Downtown West

Amendments to the 2014 Diridon Station
Area Plan

October 7, 2020

Downtown West Overview of Diridon Station Area Plan (DSAP) Amendments

FIGURE 2-3-3: EXISTING EAST WEST CONNECTIONS - VEHICULAR EMPHASIS

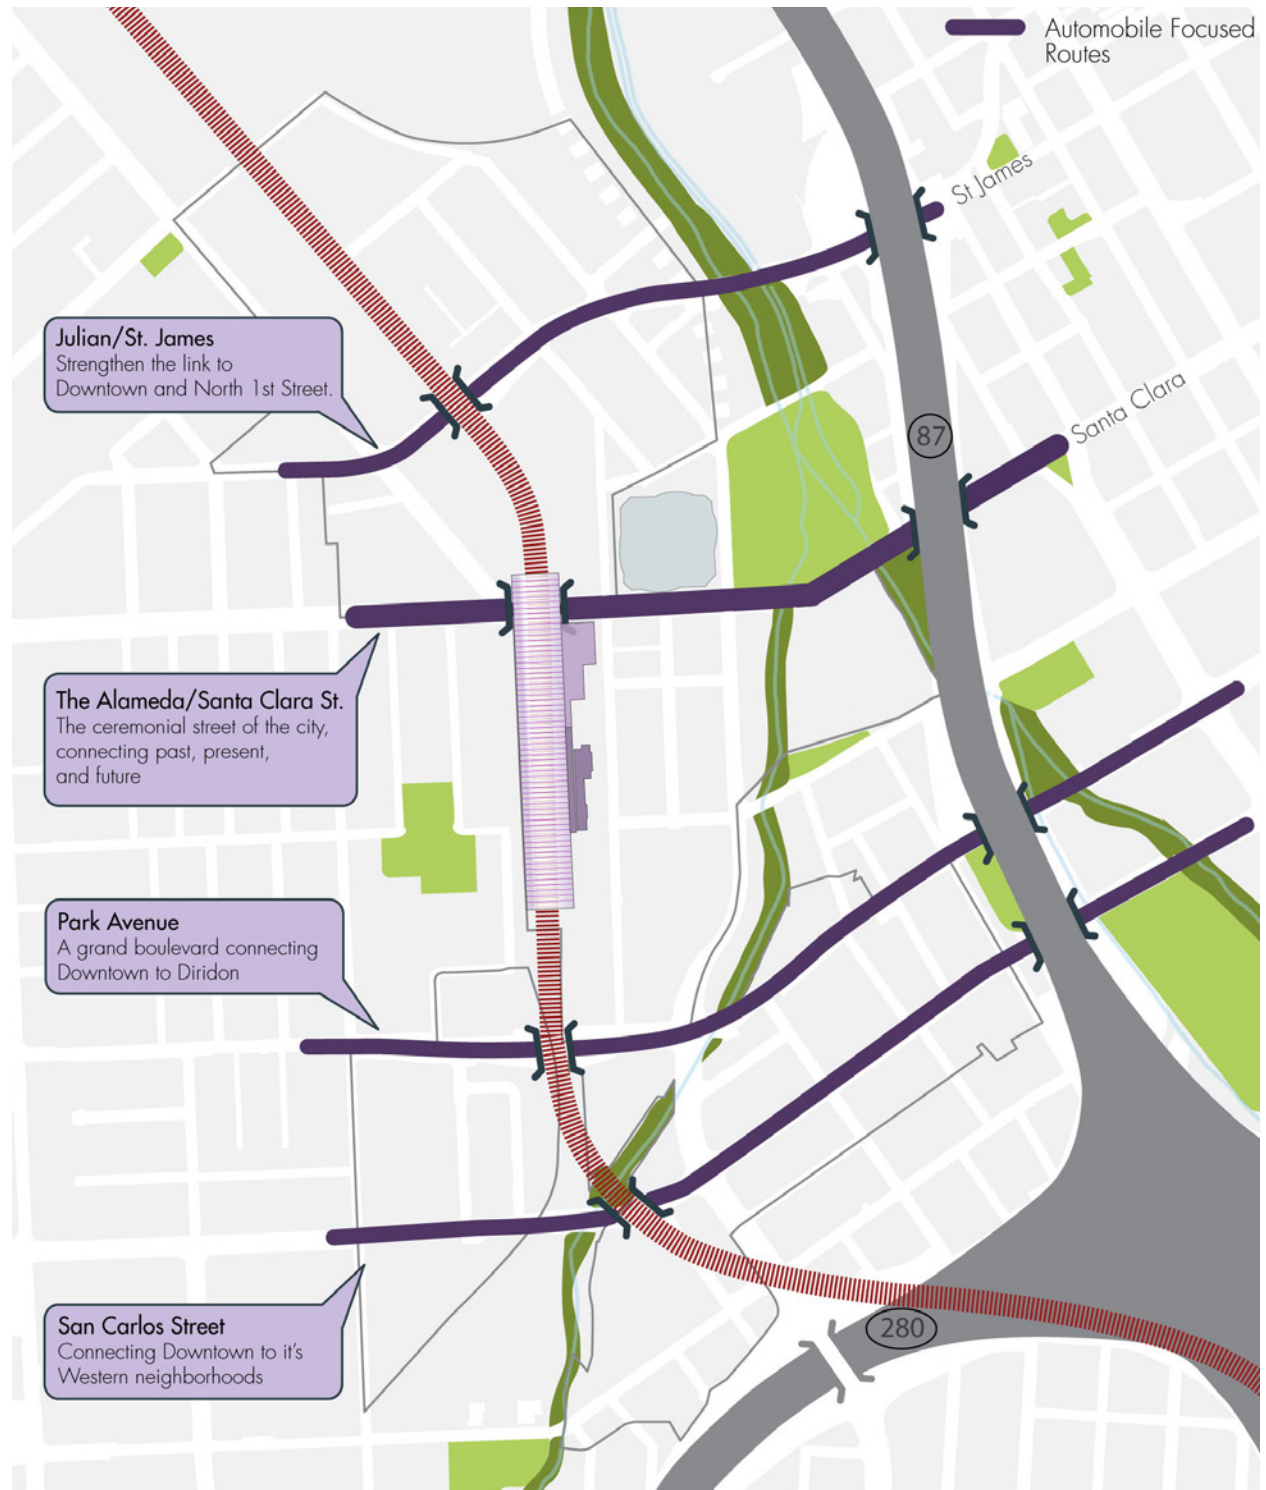
2-2-10	Test Fit Plan - Building and Uses - Southern Zone	Remove
2-3-1	Landscaping and Open Space Strategy	Amend
2-3-2	Open Space Network and Street Connections	Remove
2-3-3	Existing East West Connections - Vehicular Emphasis	Amend
2-3-4	Existing East West Connections - Pedestrian and Bicycle Emphasis	Amend
2-3-5	Wider Context Open Space Network and Connectors	Remove
2-4-1	Central Square Plaza - Illustrative Plan	Amend
2-4-2	Triangular Plaza - Illustrative Plan	Amend
2-4-3	Linear Plaza - Illustrative Plan	Amend
2-5-1	Existing and Future Ridership	No Change
2-5-2	Space Program Needs	No Change
2-5-3	Underground Level Plan	No Change
2-5-4	Station Street Level Plan	No Change
2-5-5	Station Street Level Alternative Plan	No Change
2-5-6	Station Mezzanine Level Plan	No Change
2-5-7	High Speed Platform Level Plan	No Change
2-5-8	Underground High Speed Platform	No Change
2-5-9	Station Massing from Above	No Change
2-5-10	Station Massing Looking North	No Change

FIGURE 2-6-13.1: PROPOSED NEW STREET CONNECTIONS

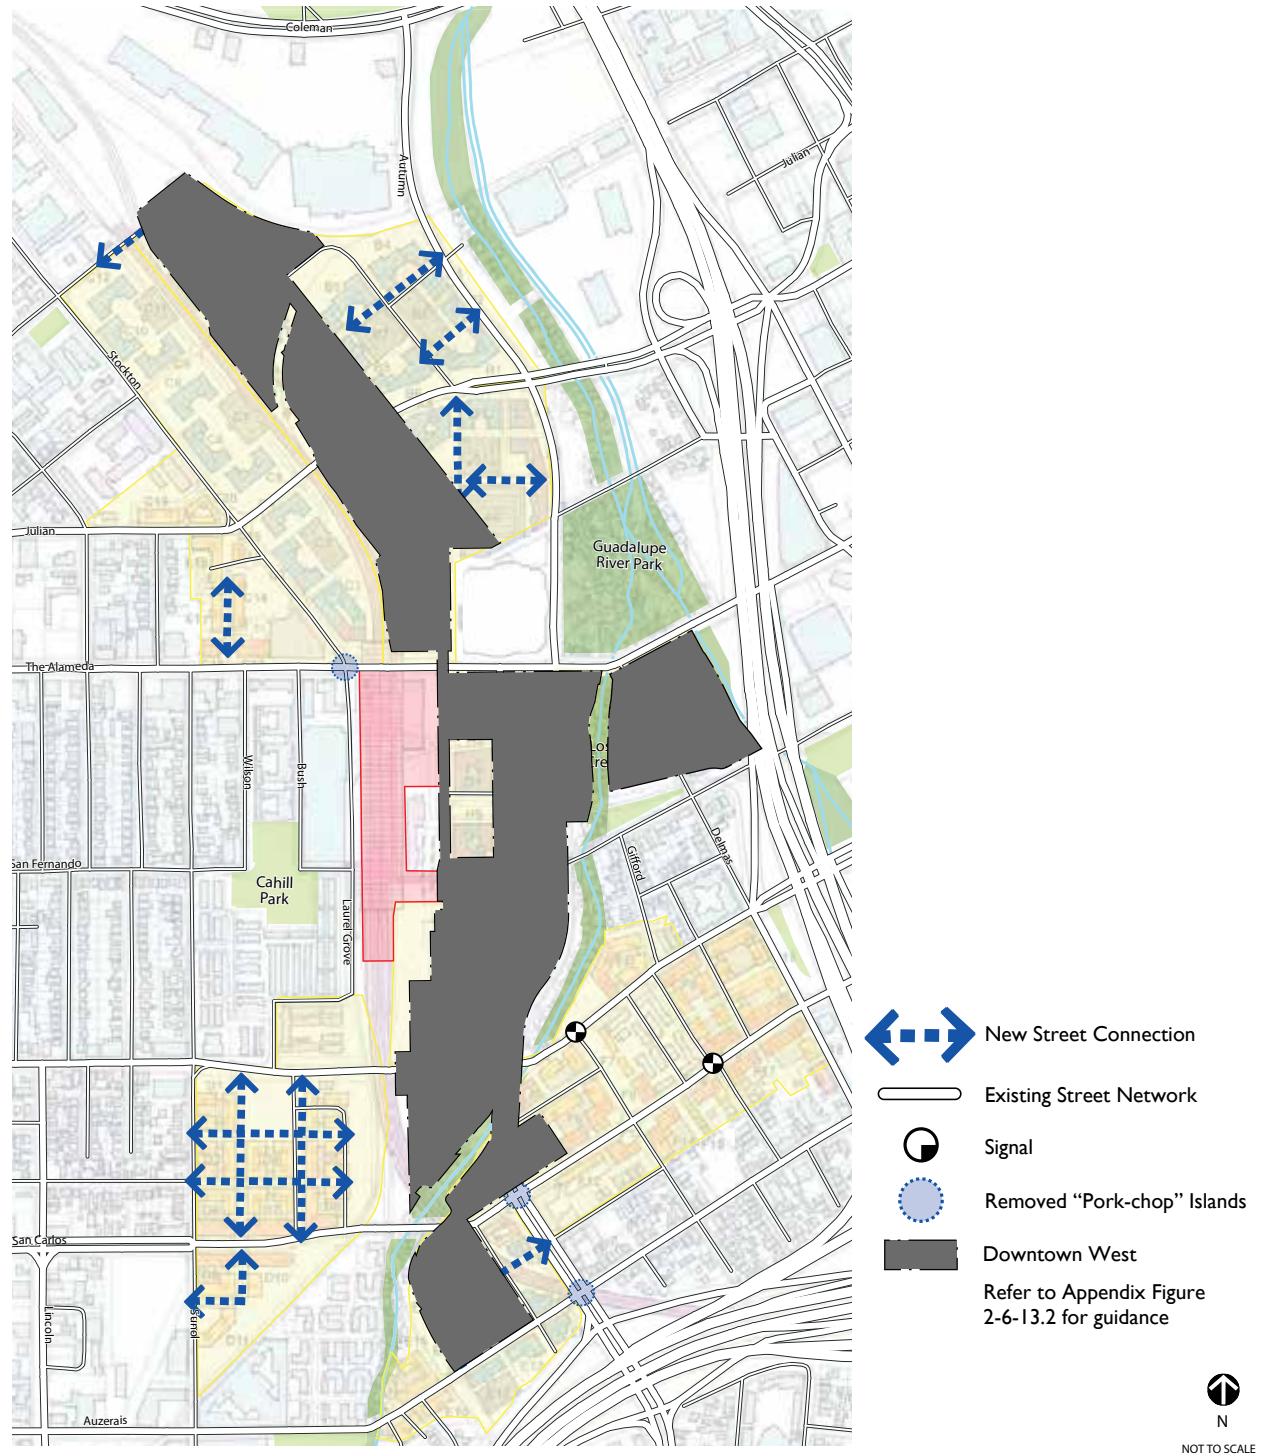
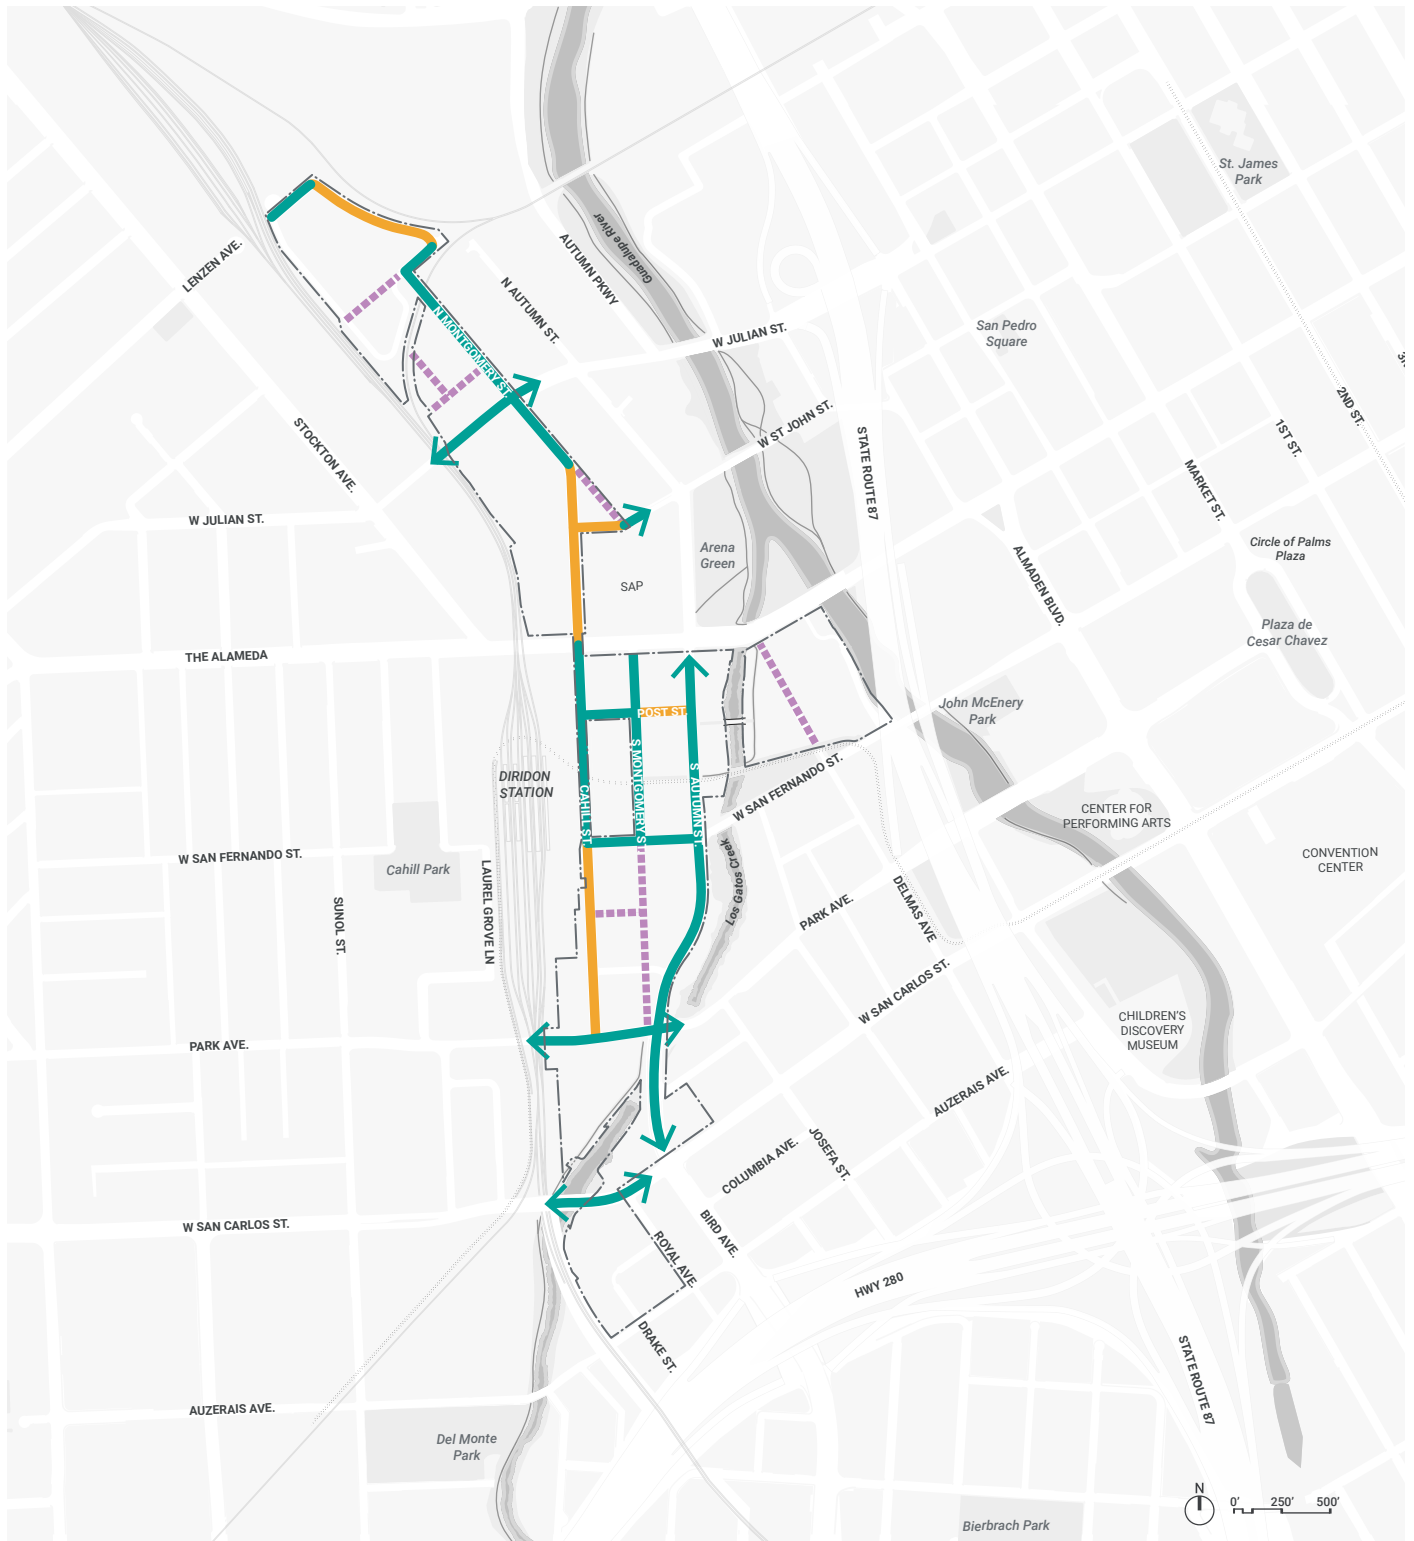
Street Connections, Transportation and Circulation	<ul style="list-style-type: none"> • Revise text and diagrams to make consistent with Downtown West. • Consider limiting text and figures for Downtown West transportation plan to minimize inconsistency between GDP and DSAP (e.g. include text and figure that shows outline of Downtown West PD Zone and refer to DWDSG).
Design Guidelines (Chapter 3)	<ul style="list-style-type: none"> • Amendments required to clarify which design guidelines need to be amended for Downtown West (e.g. building heights), and relationship between DSAP, DDG, and DWDSG. <ul style="list-style-type: none"> o Building Heights: Maximum building heights for the Downtown West area will need to be amended to be consistent with GDP / DWDSG.

FIGURE 3-2-1.1: BUILDING HEIGHTS

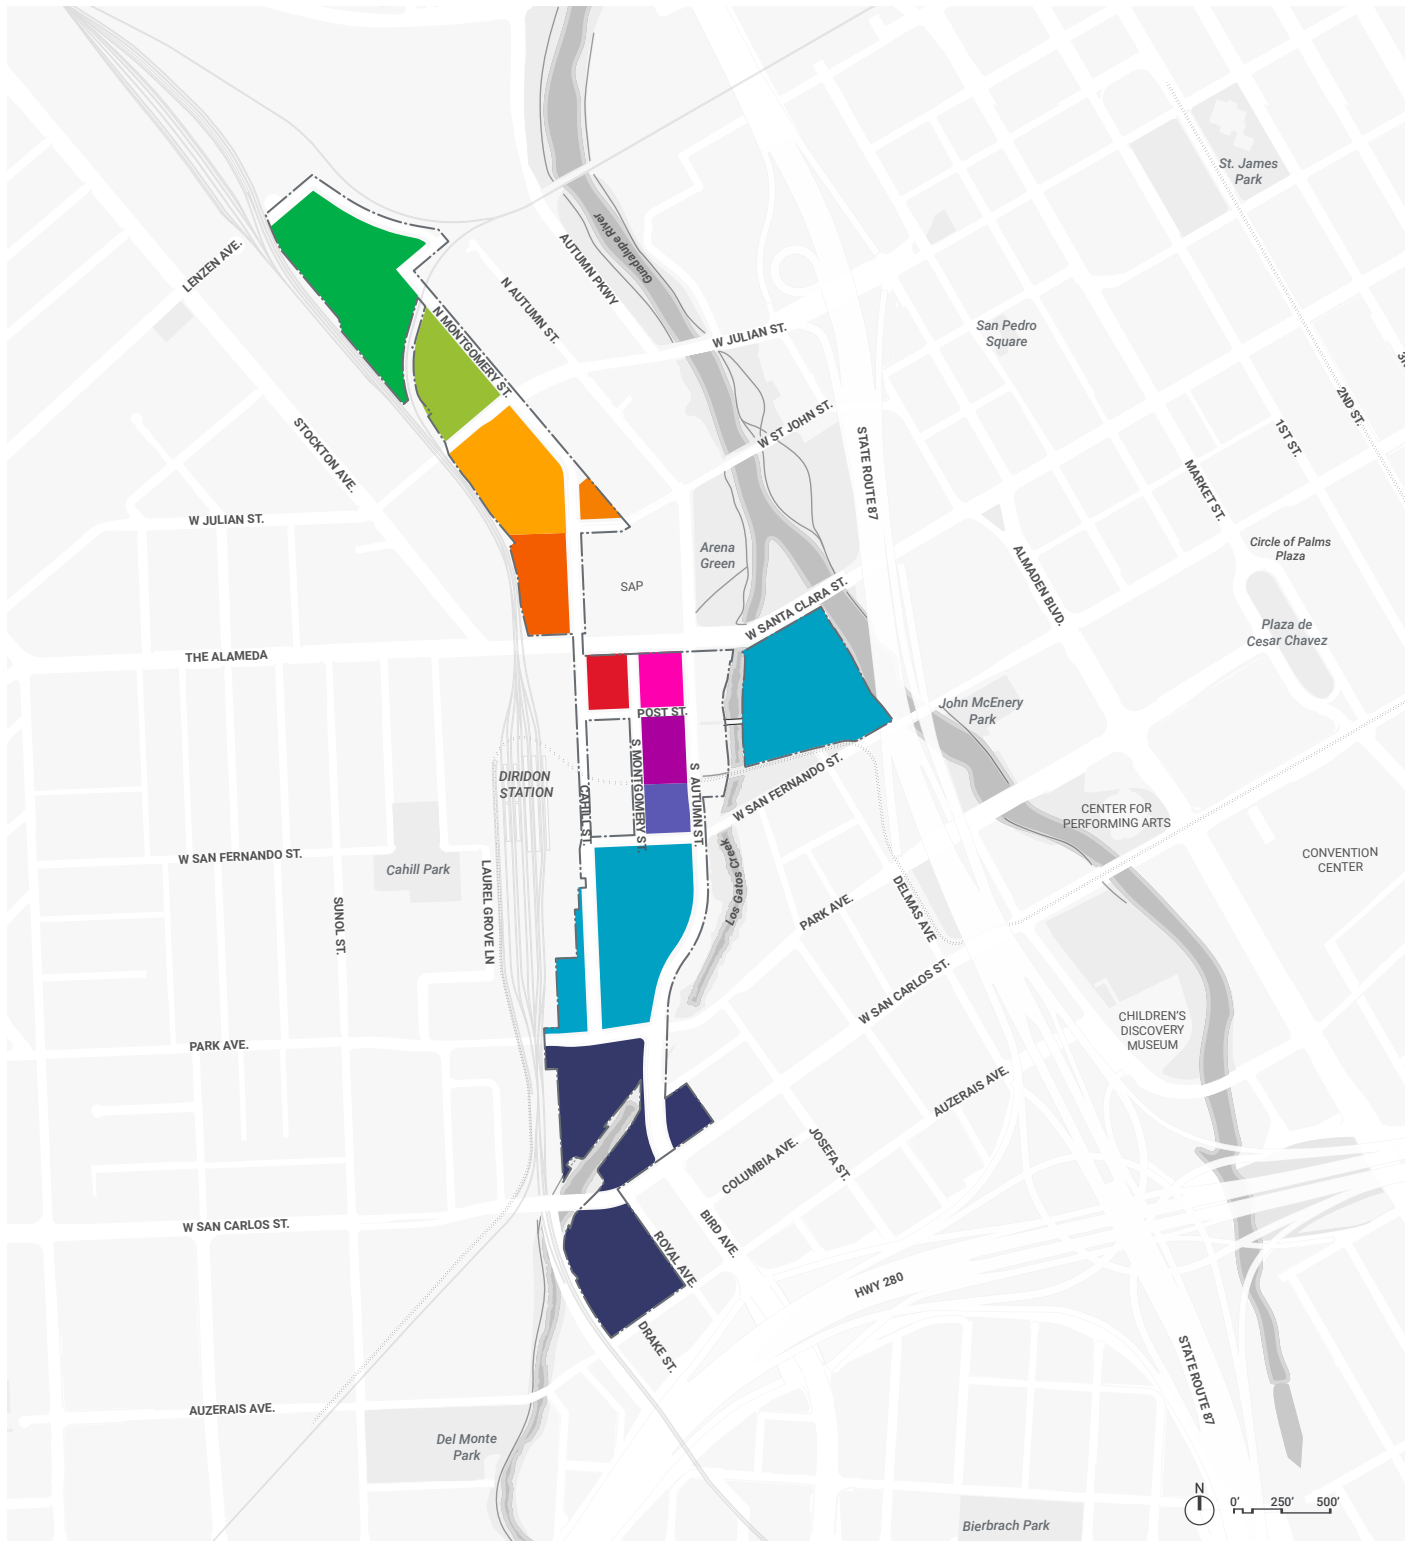
2-11-1	Art Zone Master Plan	Remove
2-11-2	Crossroads of Engagement	No Change
2-11-3	Crossroads of Innovation	No Change
2-11-4	Crossroads of Ecology	No Change
2-11-5	Potential Art Project Locations	No Change / NA
3-2-1	Building Heights	Amend
3-2-2	Typ. Sidewalk Zone in the Central District	Remove
3-3-1	Public Open Space Network	Remove
